- 1. Fisherwood Place 2022 Replat; KPB File 2022-107
Peninsula Surveying / Kieffer
Location: Jeanne Circle & North Fork Road
Anchor Point Area / Anchor Point APC**

PLAT OF
FISHERWOOD PLACE 2022 REPLAT

KPB File No.	2022-107
Plat Committee Meeting:	August 8, 2022
Applicant / Owner:	Keyton Allen and Anne Lydette Kieffer and Angelo Jim and Donna Toci all of Anchor Point, AK
Surveyor:	Jason Schollenberg / Peninsula Surveying LLC
General Location:	Anchor Point / Anchor Point APC

STAFF REPORT

Aerial View

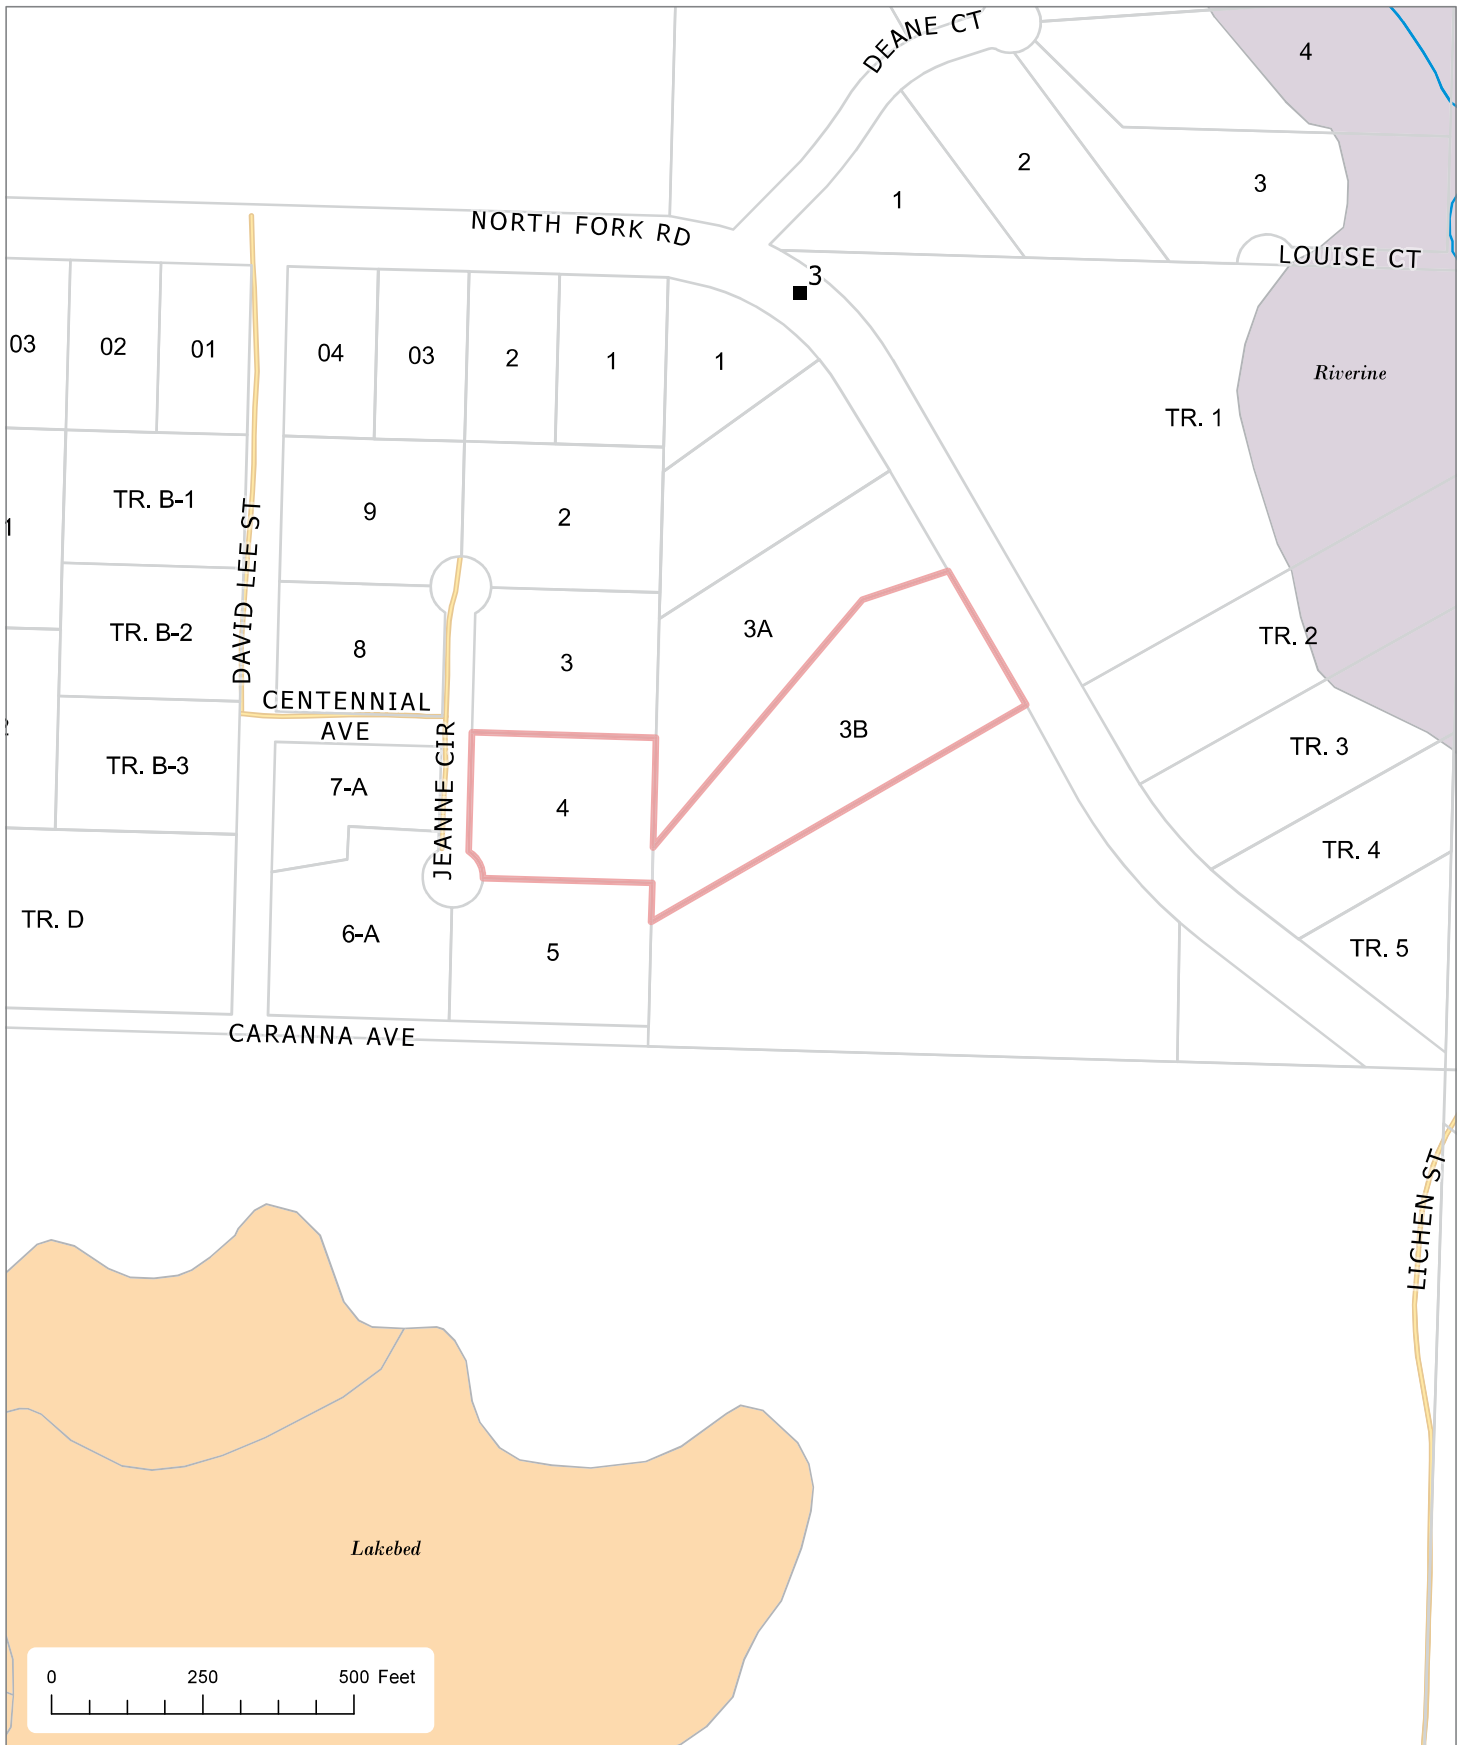
Site Investigation: Terrain in the area is relatively flat. KPB satellite imagery indicates this property may border wet areas with a pond to the South of lot 4B.

There appears to be a joint drive usage with Lot 3A to the North of Lot 4B. If this is going to be a continuing use, a drive easement needs to be depicted, filed and shown on the Final Plat. If not, a note needs added to the Final stating new access is being acquired from the State of Alaska.

Staff recommendation: *Access to 4B currently is from the North on Lot 3A. if this is to continue, and easement document for ingress / egress needs to draw up and filed.*

Staff recommendation: place a note on the final plat indicating any person developing the property is responsible for obtaining all required local, state, and federal permits, including a U.S. Army Corps of Engineers wetland determination if applicable.

Wetlands

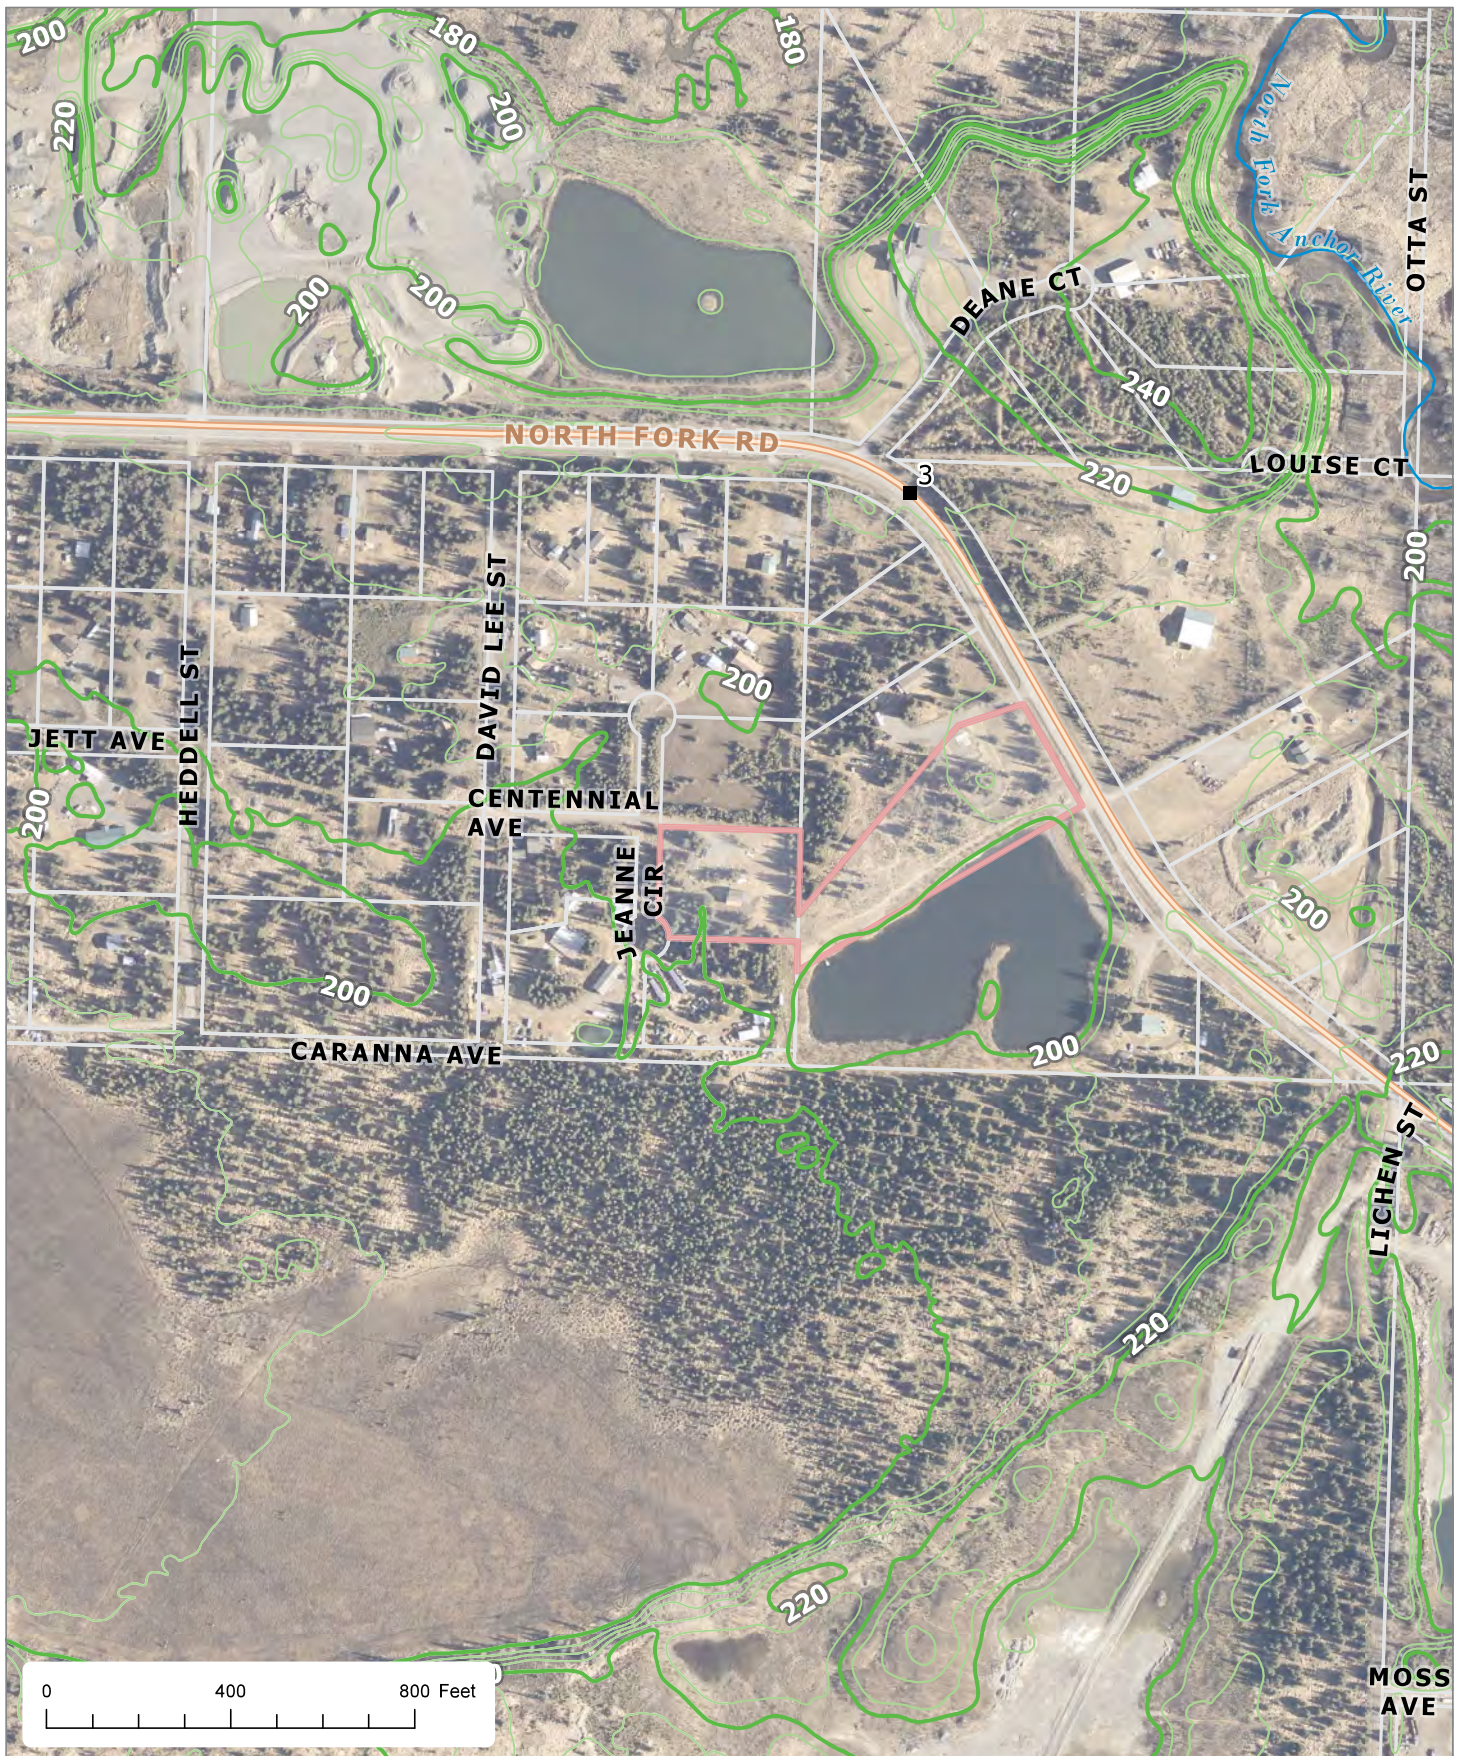
- H. Approximate locations of low wet areas, areas subject to inundation, areas subject to flooding or storm water overflow, and the line of ordinary high water. This information may be provided on an additional sheet if showing these areas causes the preliminary plat to appear cluttered and/or difficult to read;
Staff recommendation: There is a lake on the lot to the South depicted as BK 21 PG 206 HRD.
